FIELD CHANGE ORDER

NUMBER: DS-630Q2-F001

FCO DS-630Q2-F001

INTERCONNECTION OF MIRA MODULES (SYSTEM A only is shown)

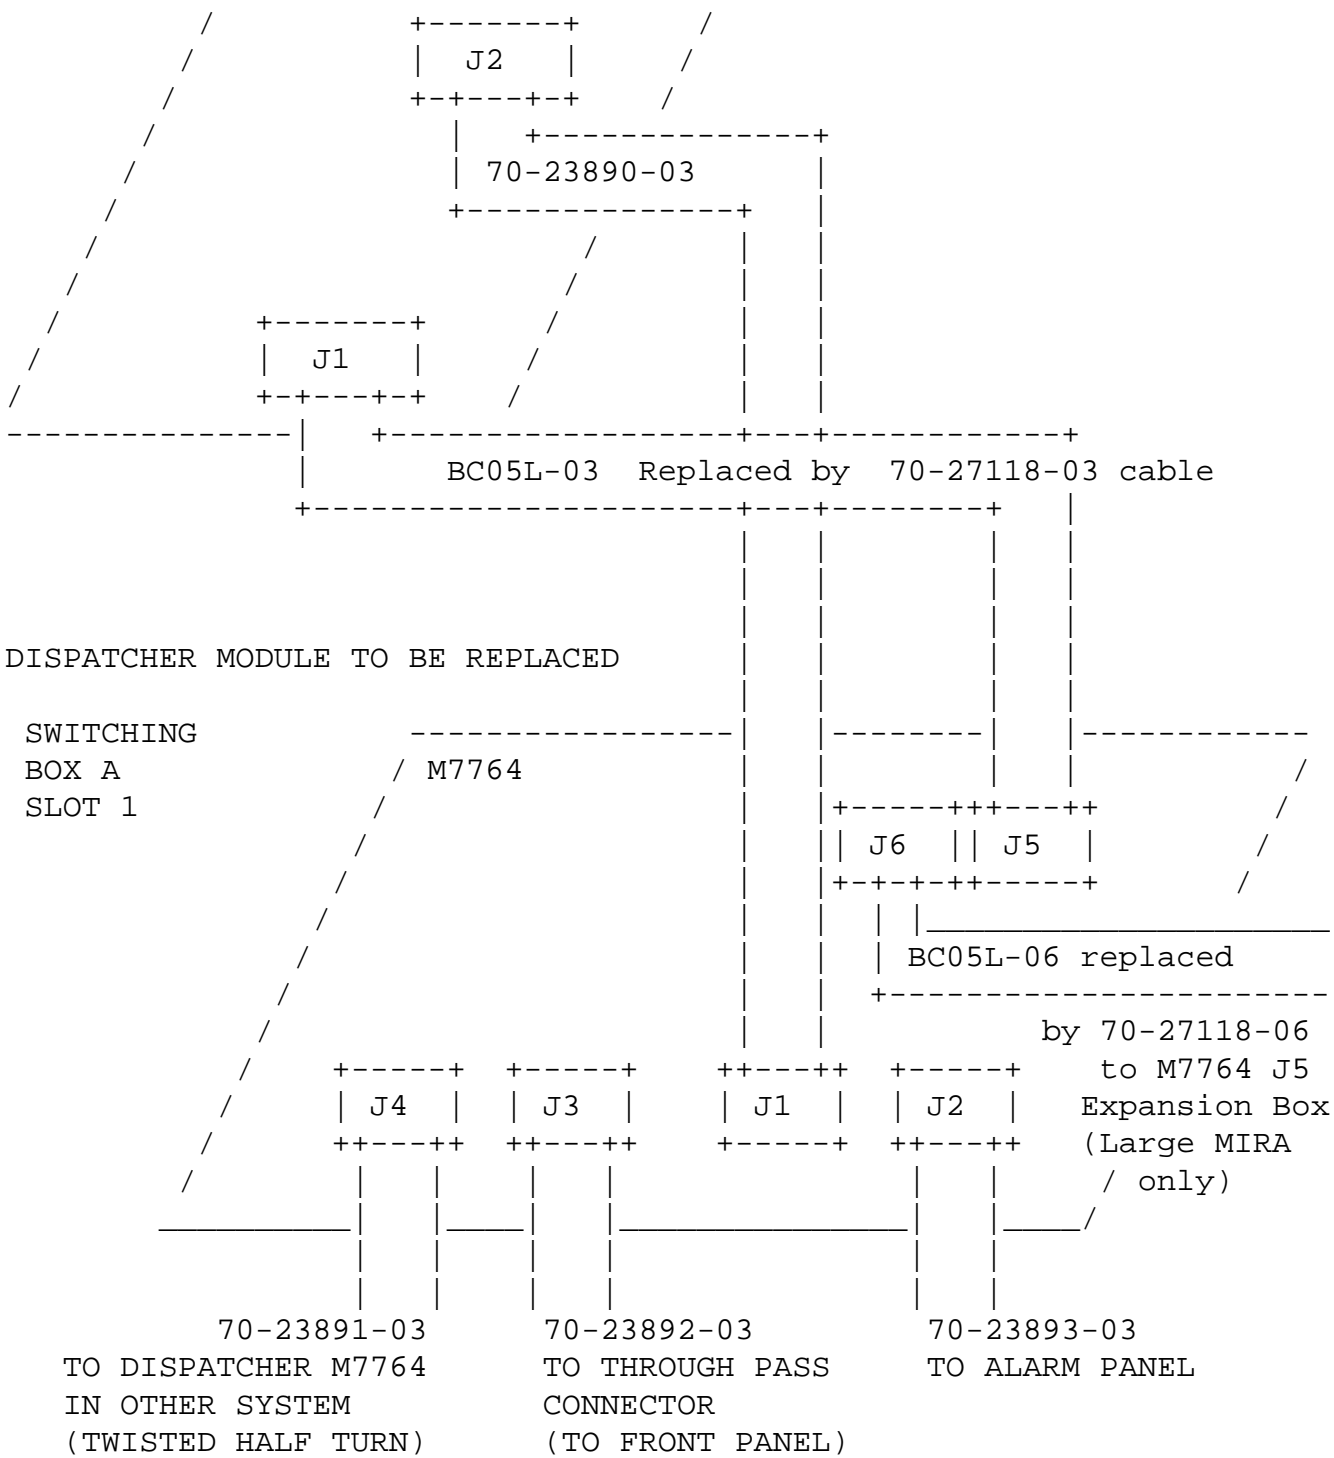
WATCH DOG MODULE TO BE REPLACED

COMPUTER A
CPU BOX SLOT 3

/ M7763 /

The interconnection of the modules and cables to be replaced is shown on Page 4.

Replace all modules M7763 and M7764 at Revision D or below by new modules at Rev E and replace BC05L dispatcher cables at one time.
